## RESPONSE TO THE REQUEST FOR REVIEW

Bureau Veritas Certification had performed the validation of the CDM Project 3262 - "*Siam Cement (Thung Song) Waste Heat Power Generation Project (TS46 Project)*". Subsequently, there have been nine requests for review raised by EB on 06/09/2010. We would like to provide our joint responses (PP's as well as DOE's) to the issues raised.

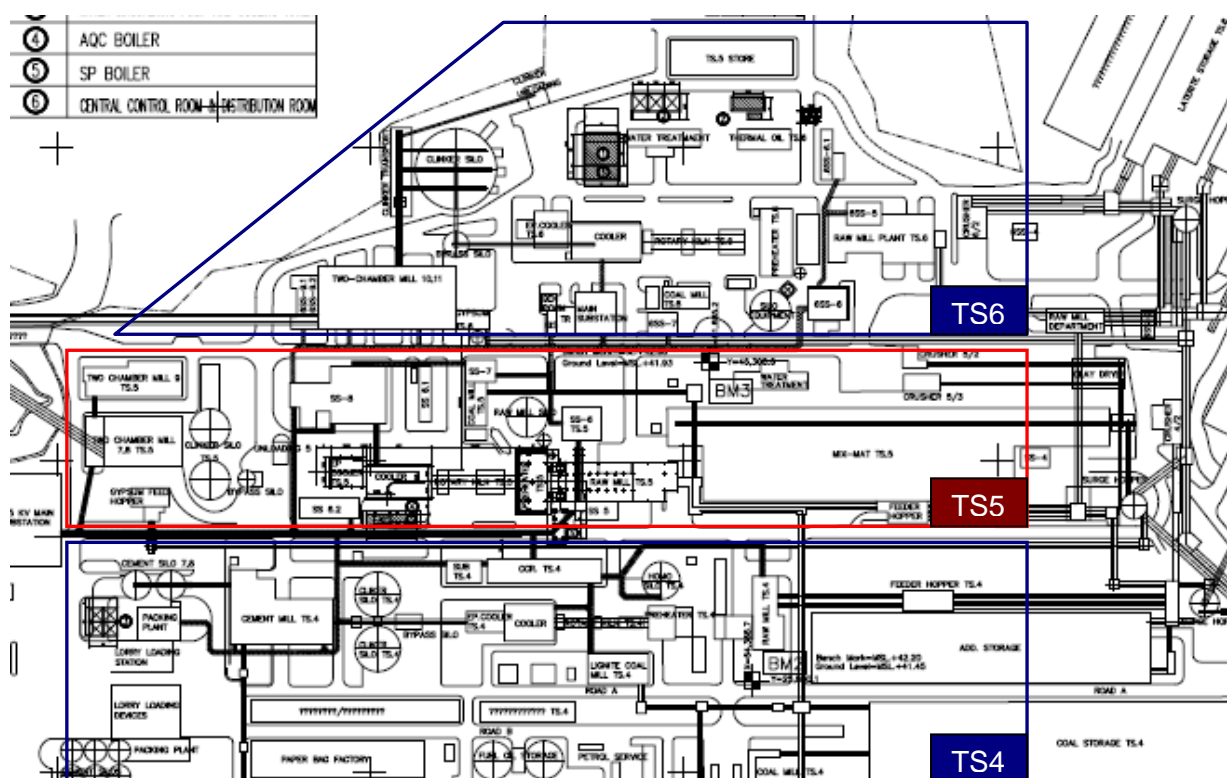
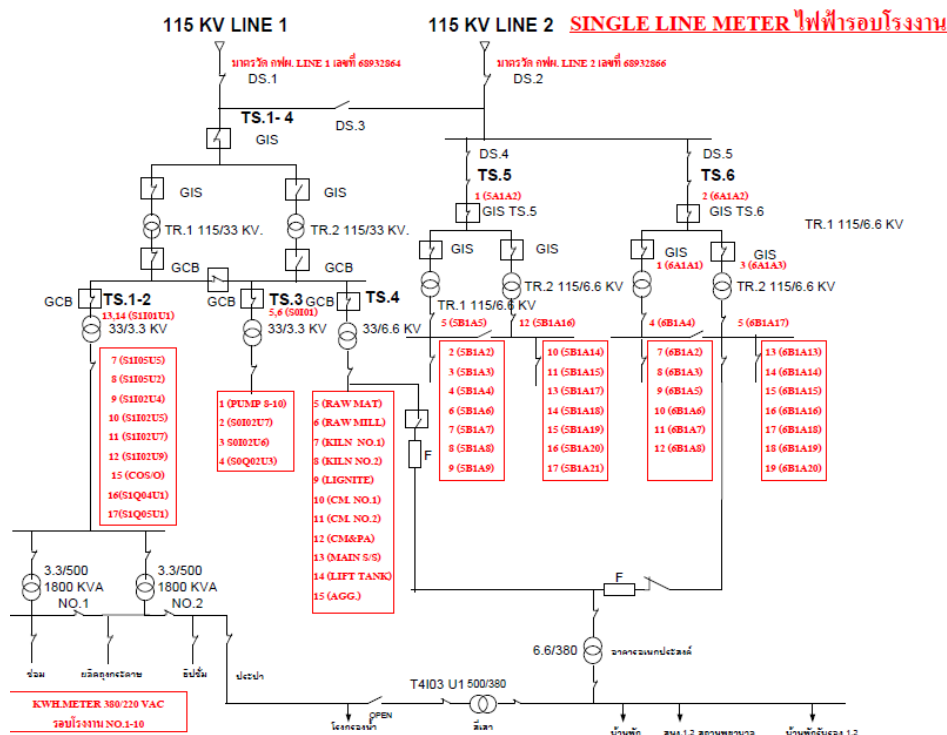
**Issue 4:** DOE is requested to further substantiate the appropriateness of the project boundary and facilities included in the boundary, in particular the Kiln 5 and internal grid in line with the requirements of VVM/ver.1.2, para. 78-80.

Under Section B.3 of the PDD, the physical boundary of TS46 is defined as the facilities constructed/erected on account of the project activities and the local power grid system (meaning the national grid supplied by EGAT). There is no captive power plant within the project boundary, which denotes that no captive power plant exists for clinker production line 4 and 6. In contrast, for the whole TS plant [on page 18], there is a captive power plant at the clinker production line 5, but the clinker production line 5 is separate from the clinker production line 4 and 6. As such, TS5 WHG is excluded from the project boundary and that Kiln 5 (TS5) and the electricity generated from its WHG system are clearly distinct from the project boundary of TS46, as further substantiated below.

The plant layout below shows the clinker production line TS4, TS5 and TS6. Each line has on its own complete stand-alone production facilities from raw mill and fuel mill until the clinker silo so that each production line can be in operation independently of the other line. The plant layout also shows that the existing TS5 WHG is located outside the physical boundary of the project.

The independence of electricity use between TS5 and TS46 can be further demonstrated by the single line diagram. As shown in the attached single line diagram [STS EE diagram TS4 5 6.pdf] /A-18/ , the electricity line is connected between TS4 and TS6. However, the TS5 electricity system is separate to TS46. TS5 WHG is connected and supplies electricity to TS5 production line only. Similarly, TS46 WHG will be connected to clinker production line TS4 and TS6, and located in a close vicinity of line 6 (because TS6 production line is more efficient than TS4, so that TS6 will be utilised before TS4).

TS5 WHG is not considered as internal grid for TS46 since it is not possible to export electricity from clinker production line TS5 itself. This is because the TS5 WHG can generate 7.30 MW of electricity only when the clinker production line 5 is operating, which requires approximately 22 MW of average electricity demand (average from the total plant demand of 65 MW for 3 clinker production line), although the rated capacity of equipment installed in TS5 production line alone is totalled 43.80 MW [TS5\_demand.xls] /A-19/ as supported by equipment specification .When the clinker production line 5 is not operating, the TS5 WHG cannot generate any electricity. Therefore, TS5 WHG cannot supply any electricity to the project activity and should not be considered as internal grid for the project activity.

During site observation, validation teams have carefully checked project boundary with plant layout and single line diagram and found that TS5 WHG is excluded from TS46 project boundary and confirm that TS5 WHG is not captive power plant within project boundary . In addition, the TS5 could not export electricity from clinker production line 5 because its electricity generation is lower than clinker production line electricity requirement.

Without operation of clinker production line 5, the TS5 WHG could not generate electricity. Therefore TS5 is not internal grid for the project activity.
